AGENDA
Molalla Planning Commission
6:30 PM, April 6, 2022

- SDR05-2021 – 12763 S Hwy 213
(Colima Apartments Phase II)

Date: March 30, 2022 for the April 6, 2022 Planning Commission Meeting

**PRELIMINARY SITE PLAN
 COLIMA APARTMENTS PHASE 2
 12763 S CROMPTONS LANE
 MOLALLA, OREGON**

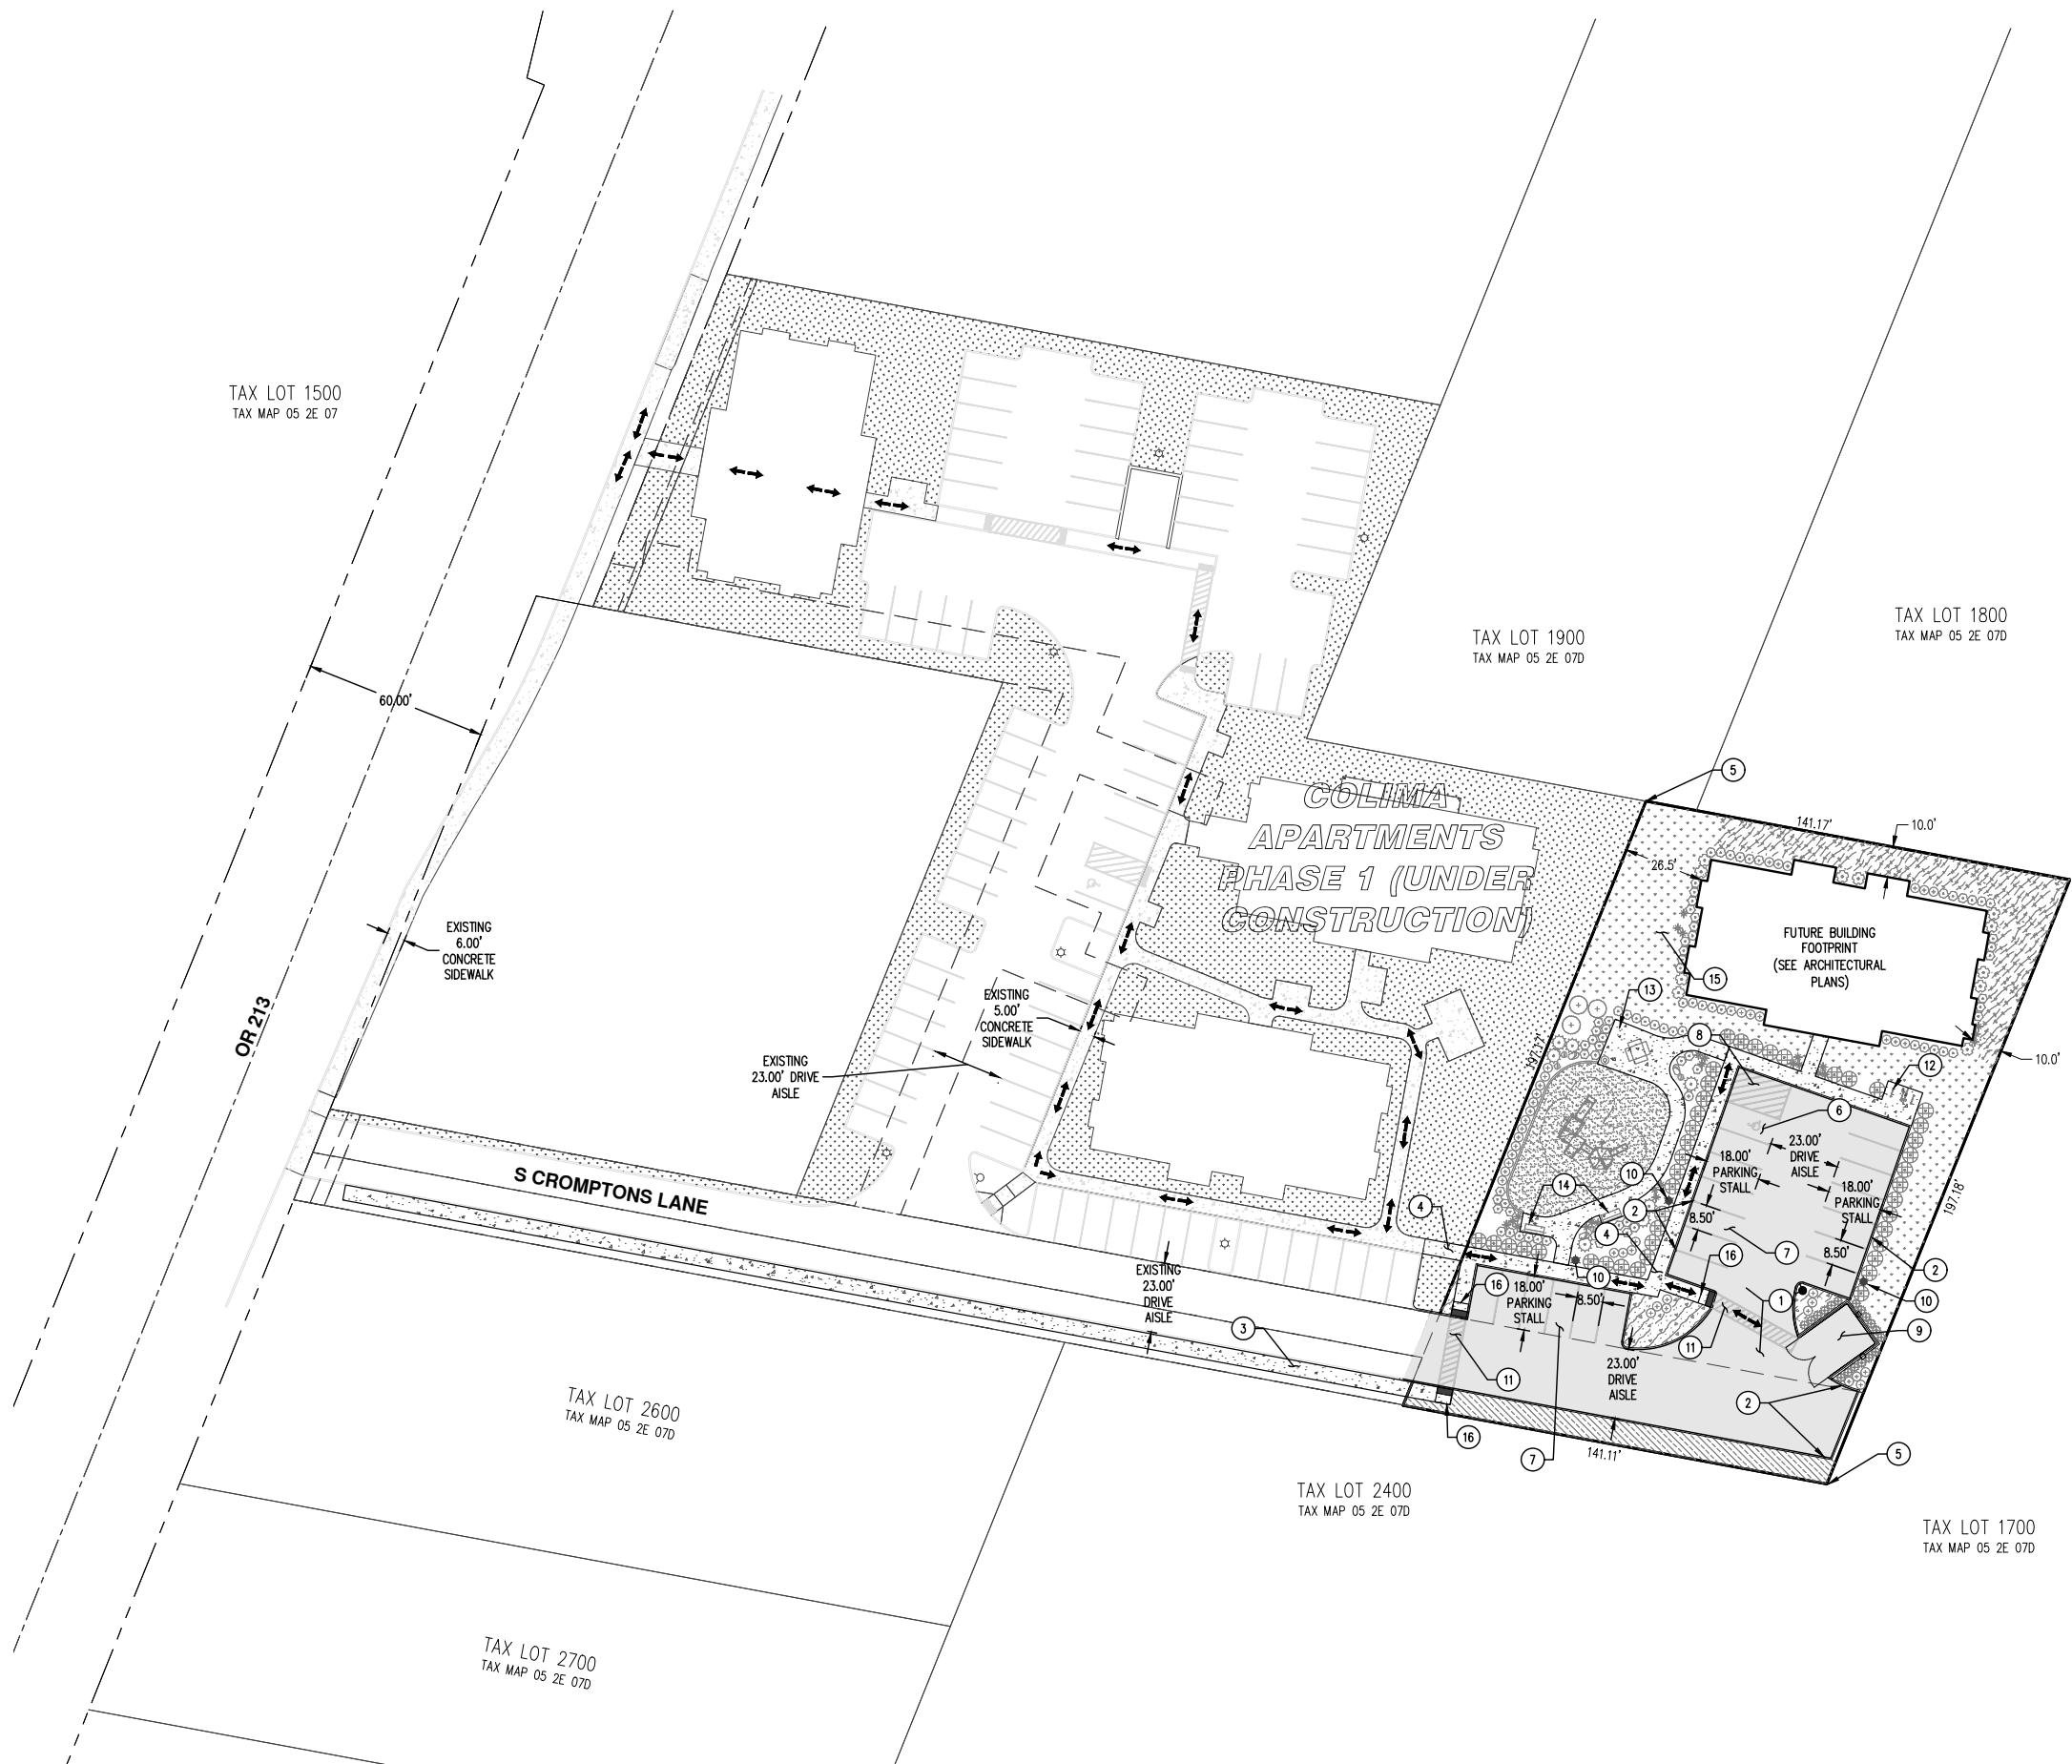
- b. The Applicant shall design the portion of the ADA pedestrian approach and sidewalk adjacent to OR-213 and south of the proposed access to the edge of the southern property line and submit it with revised site plans. Work within the ODOT ROW will require ODOT permitting.

- c. The Applicant shall design the walkway abutting the southern portion of the property to extend to the pedestrian sidewalk along OR-213.
- d. The Applicant shall submit a lighting plan that modifies wall mounted light arrangements to limit spillover onto properties to the north and east.

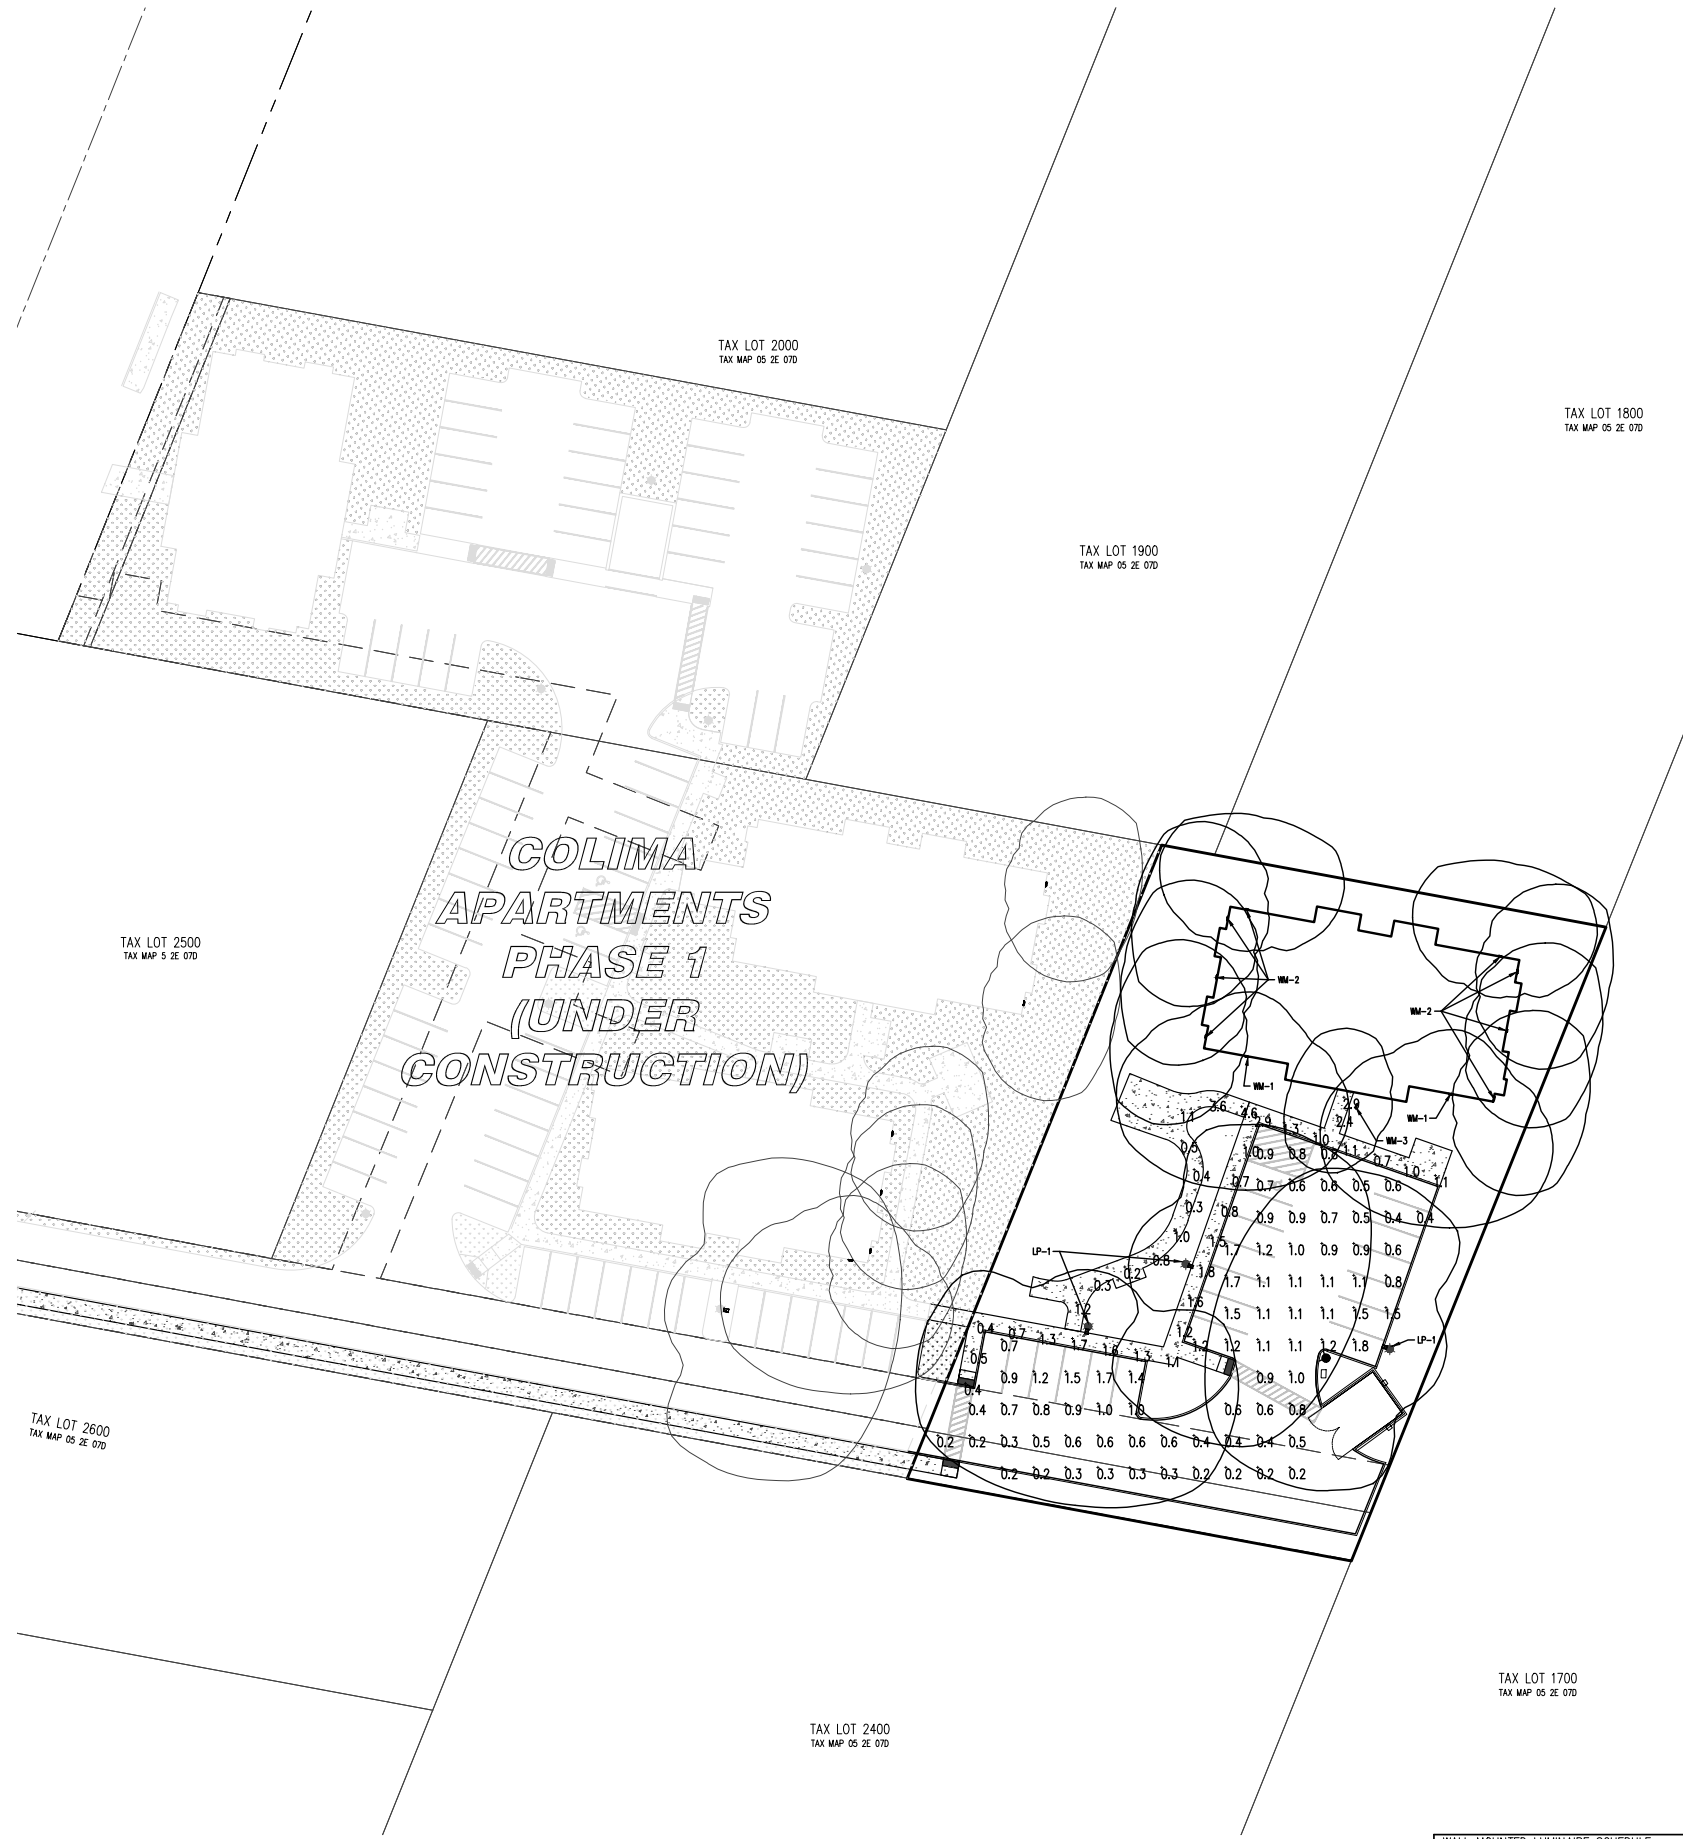
- e. The Applicant shall submit a lighting plan showing walkway lighting along the southern border of the access road meeting the standards of MMC 17-3.050 C, 6.

**PRELIMINARY FIRE AND LIFE SAFETY PLAN
 COLIMA APARTMENTS PHASE 2
 12763 S CROMPTONS LANE
 MOLALLA, OREGON**

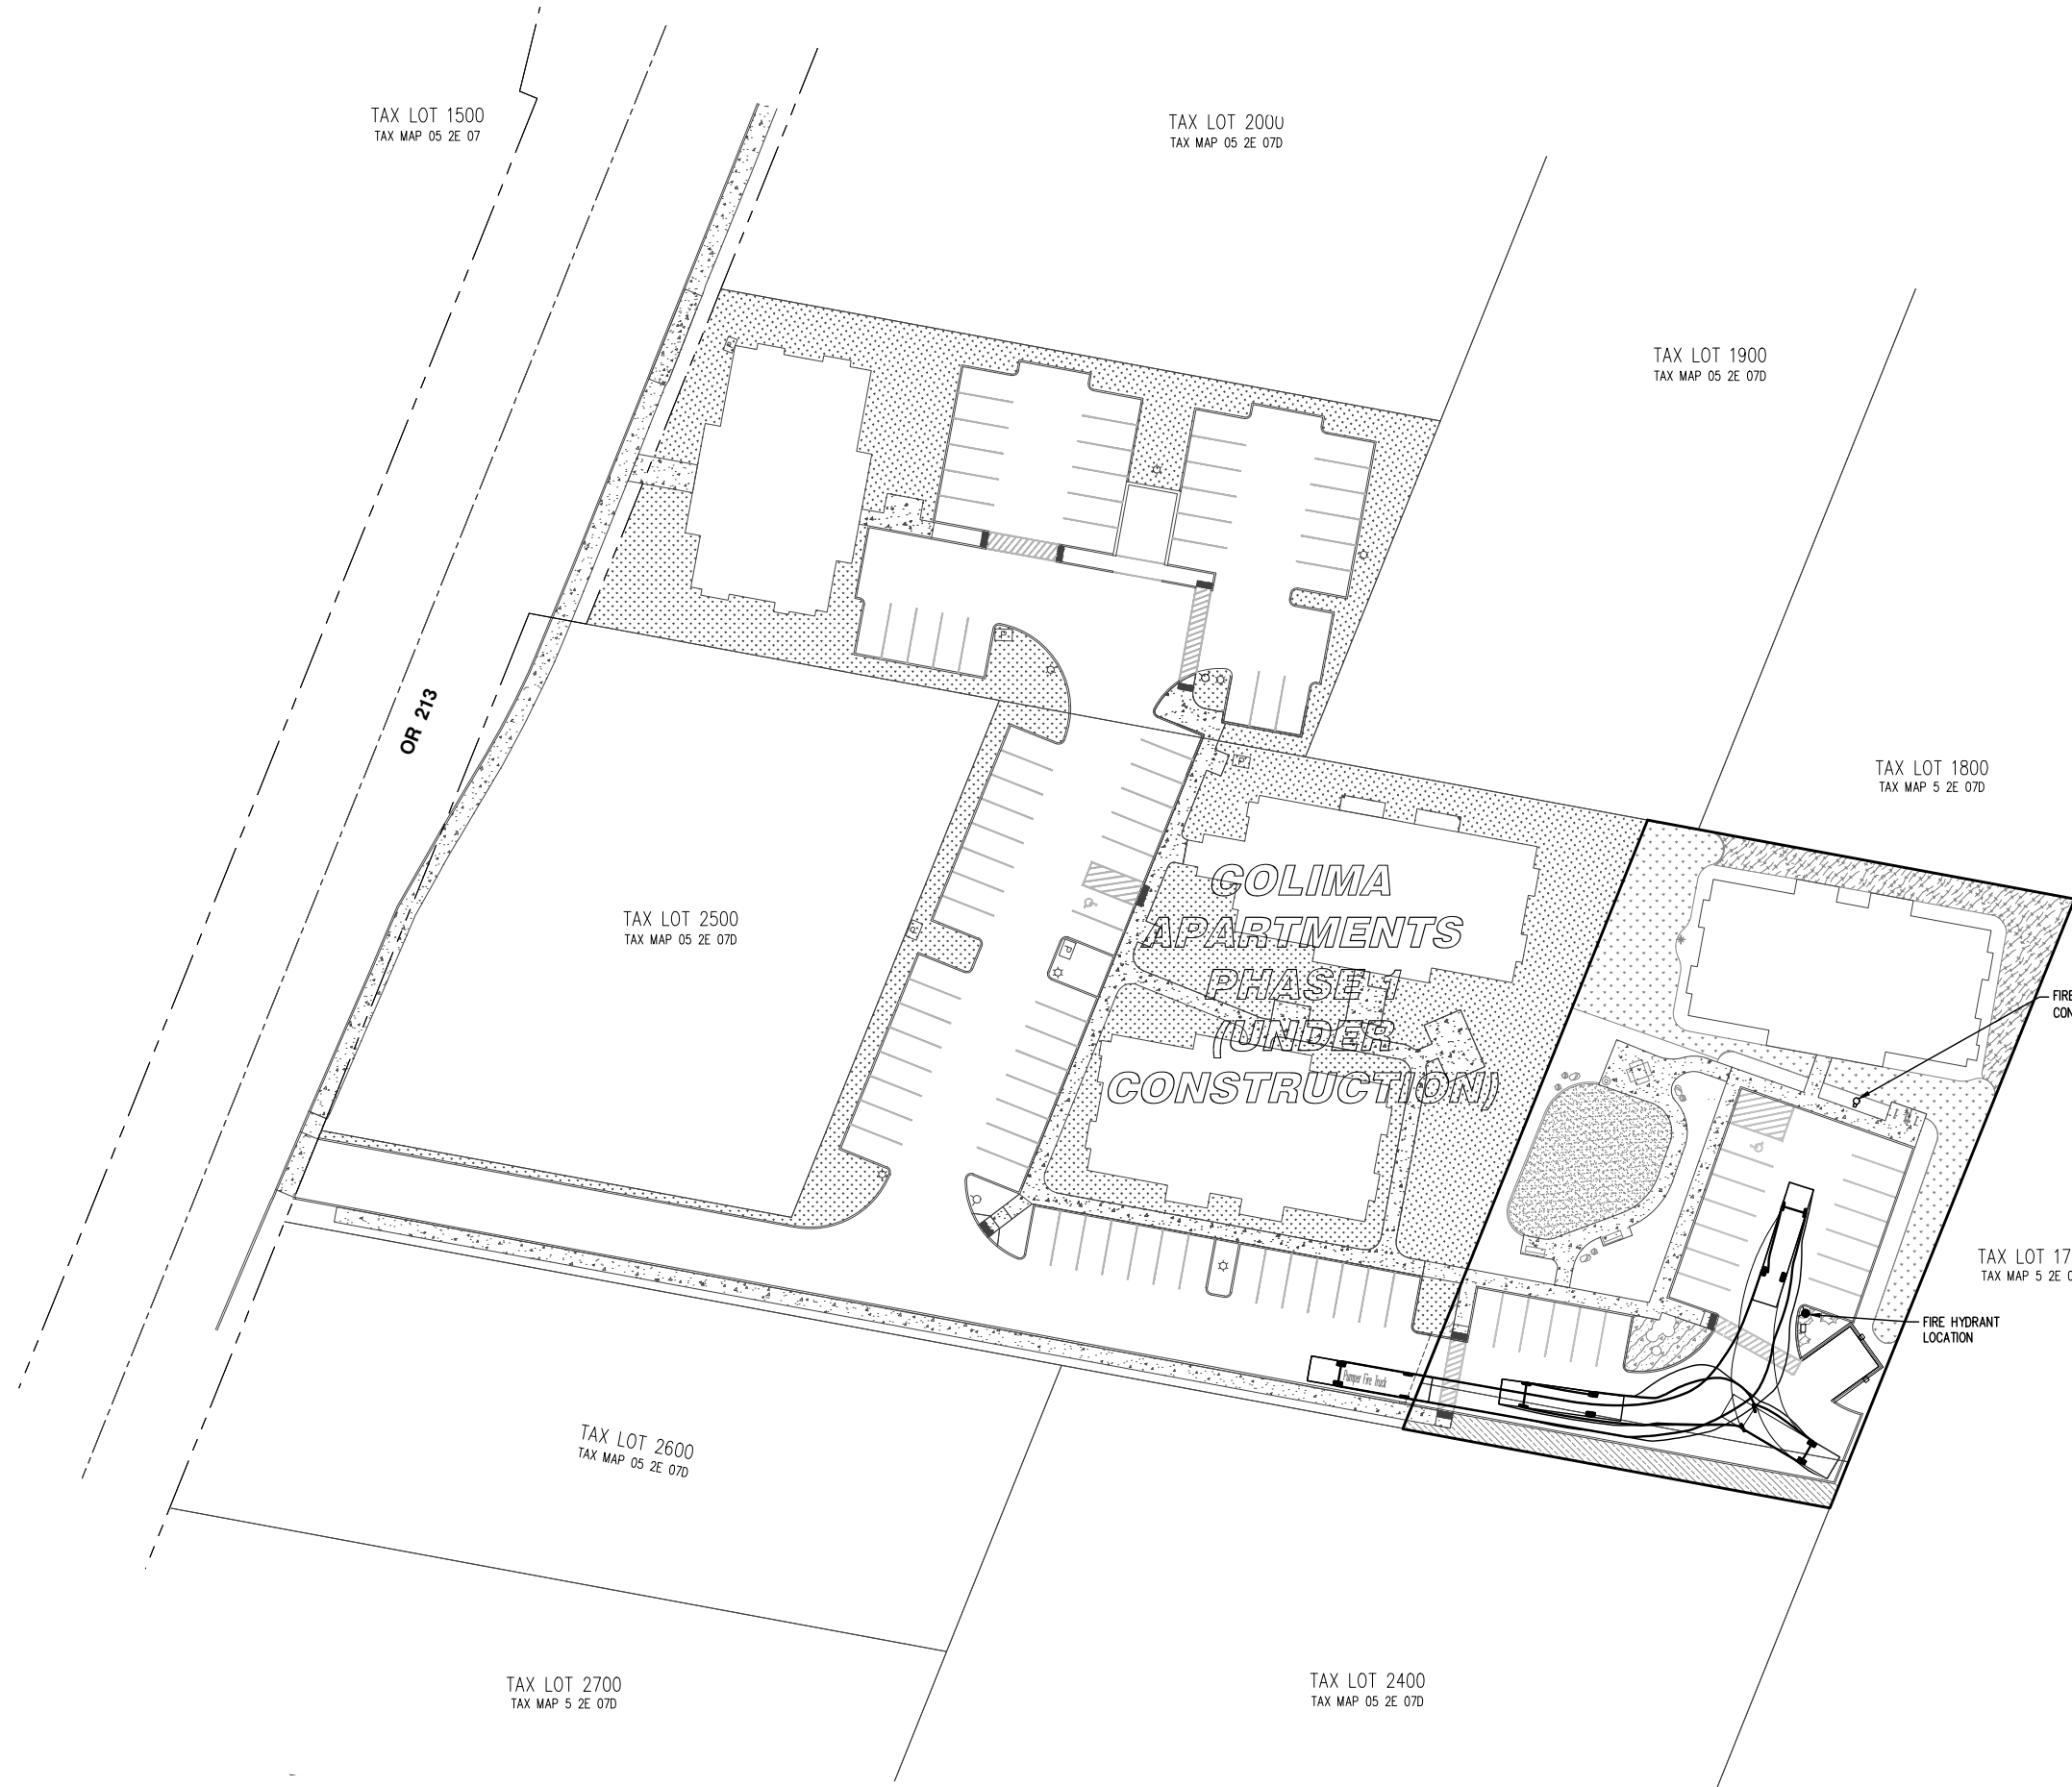
On Page P-10, It shows the curb area directly in front of phase 2 painted as no parking. The area needs to include the turning radius on the NW side of the entrance, The area on the NE side of the entrance in front of the fire hydrant and the area in front of the FDC. In addition, the no parking area needs to extend to HWY 213. See OFC D103.6.1.

I have not seen addressing signage for this complex. Address signage on the buildings shall be similar to 1111 Meadow drive and 872 W Main St. and shall be clearly visible from the access road.

Please remember that the stortz fitting is four inch and not five for the hydrant. This is a common mistake that is made.
